City of Bartlett

Municipal Planning Commission

AGENDA

Monday, December 2, 2024 — 6:30 p.m.

SHEET 3 OF 3
DIVISION OF ENGINEERING
EROSION CONTROL PLAN PHASE 3
BARTLETT, TENNESSEE

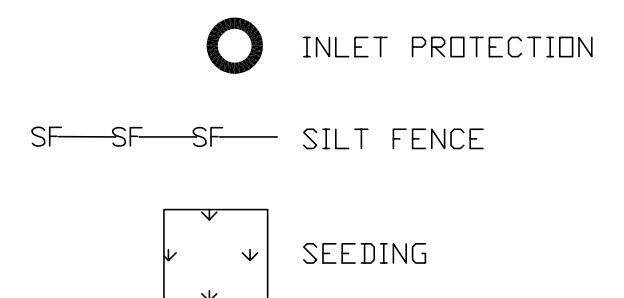
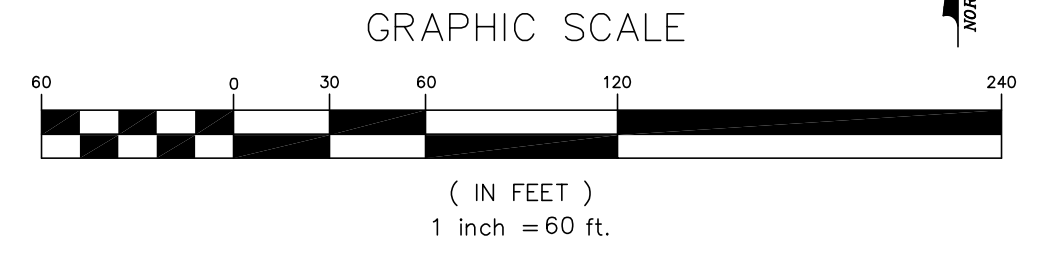
- 17) Silt fence is shown in the legend but not shown on the plans.
- 18) EPSCs to be installed behind curb and gutter until lots are final stabilized.

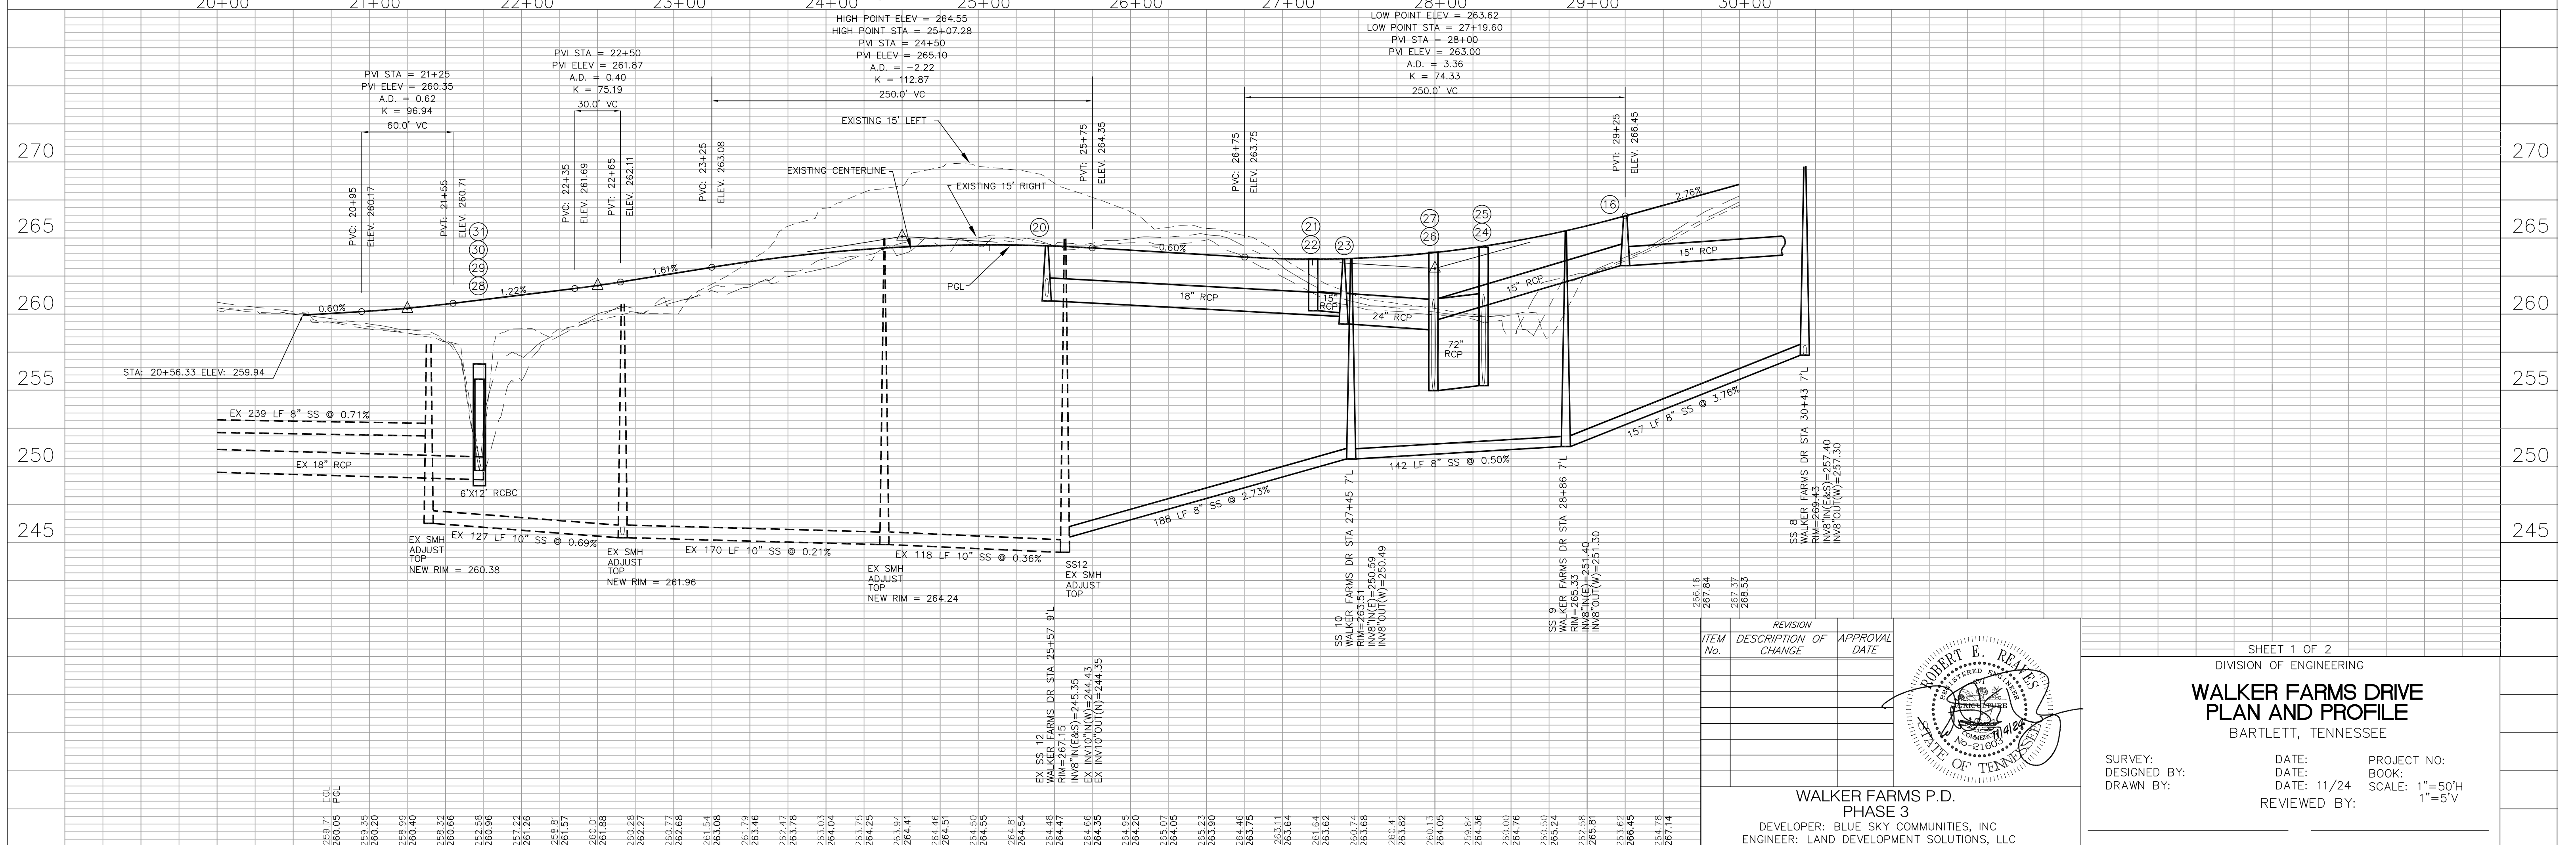
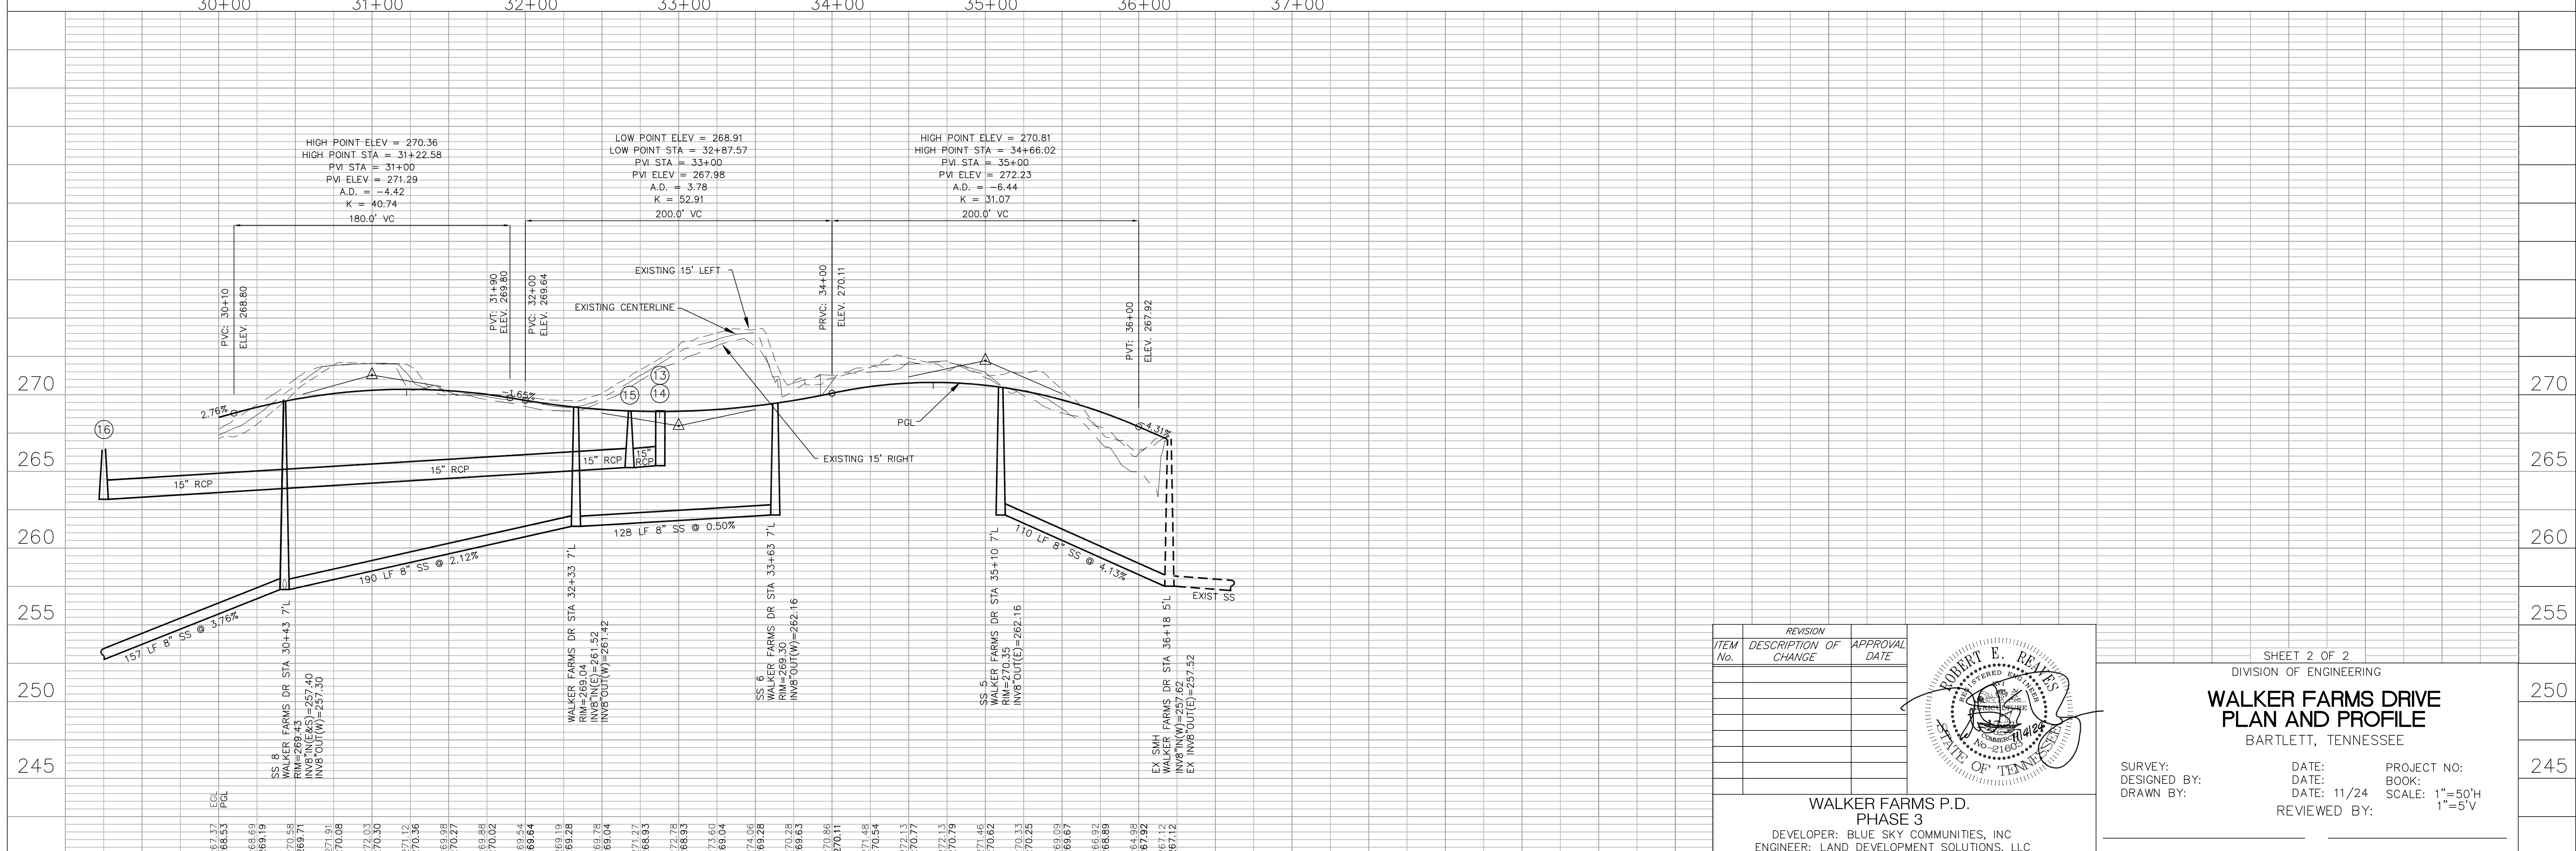
- 26) Street Section (Typical) should indicate the surface lift as 411-D as opposed to 411-E.
- 27) Street Section (Typical) has a note concerning when the wearing surface is to be installed. It shall be installed when the subdivision is 100% built out as opposed to prior to plat recording.
- 28) As-built columns are required for the structure and pipe tables.
- 29) Drainage profile should show length of runs and slopes.

OUTFALL CONTROL STRUCTURE TYPE "D" HEADWALL WITH WINGWALLS

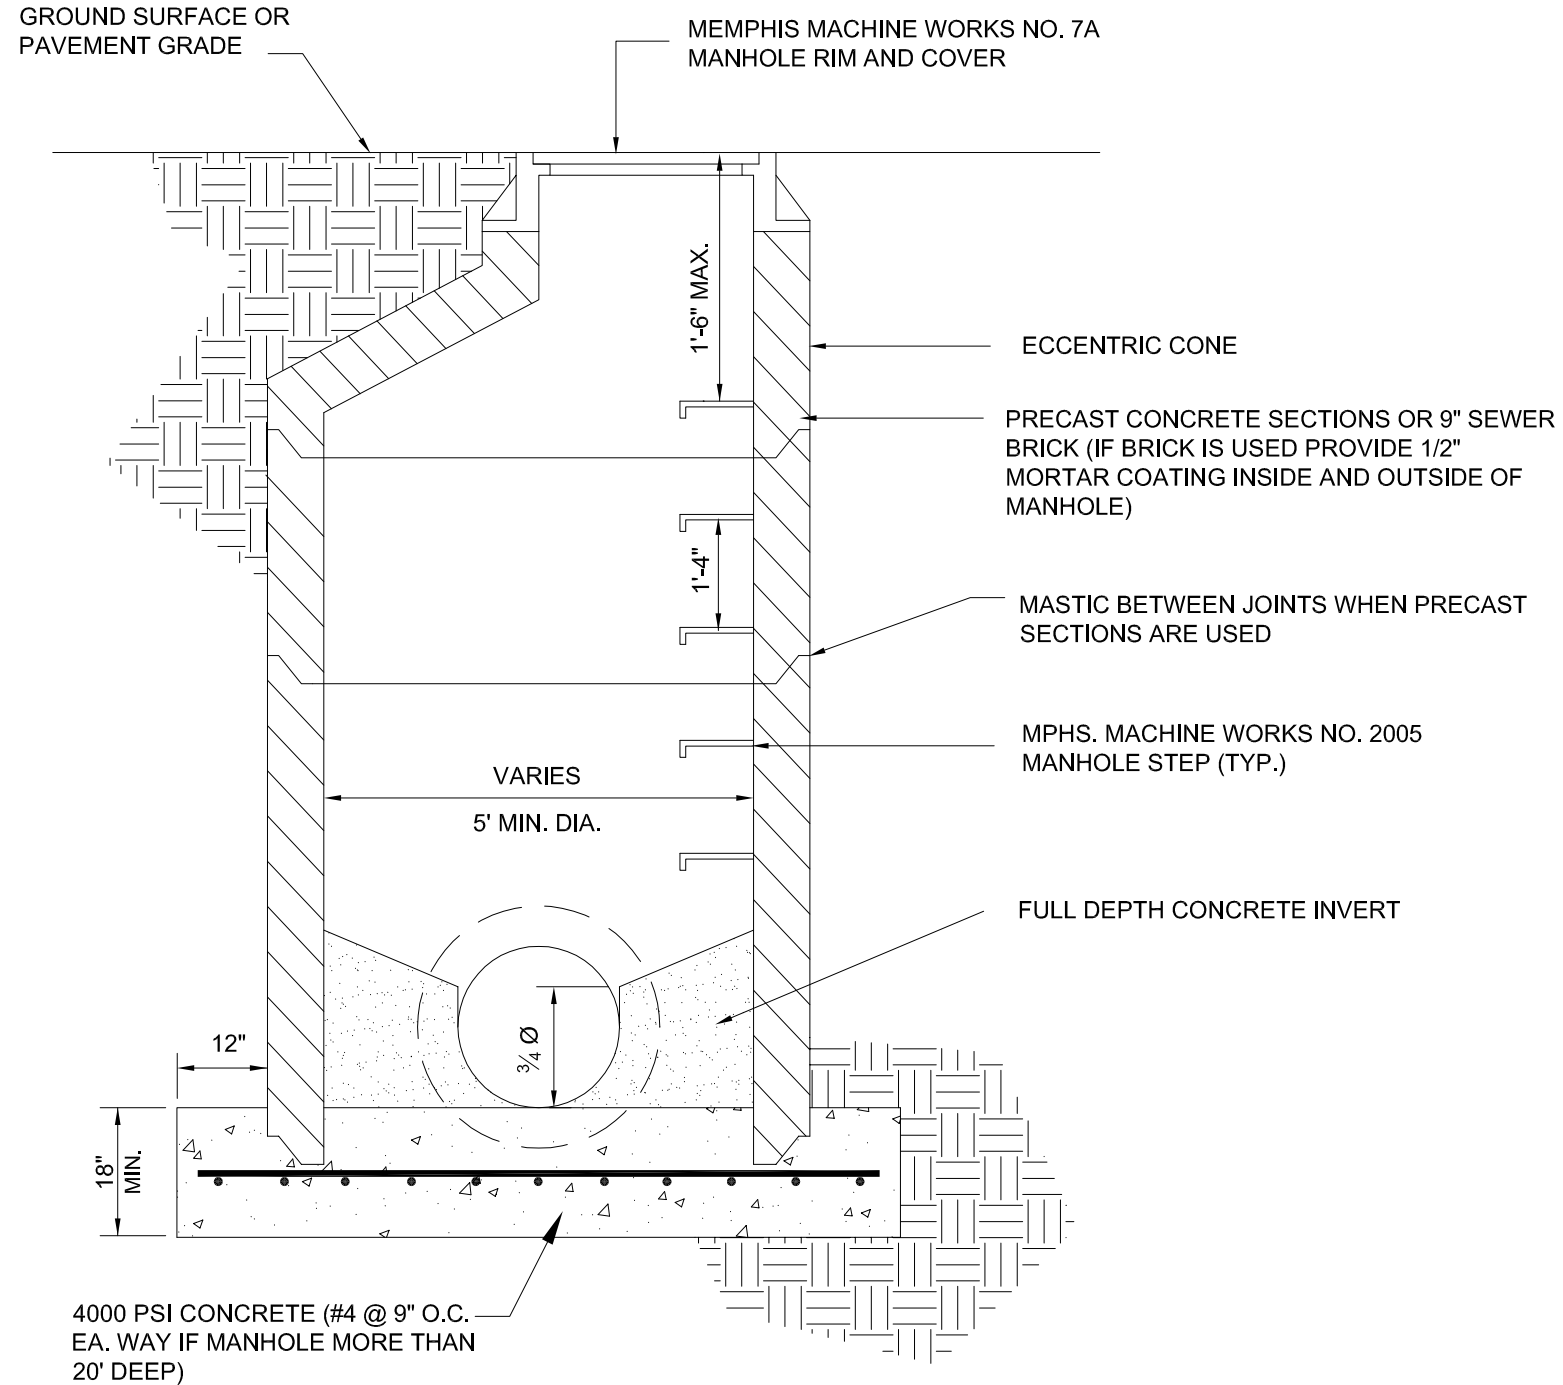
- 30) Detail for type D headwall, the inlet elevation should show a concrete apron similar to the outlet elevation.

- 32) Elevation view of wingwall has a note to see tables on a standard drawing that is not included in the plan set.
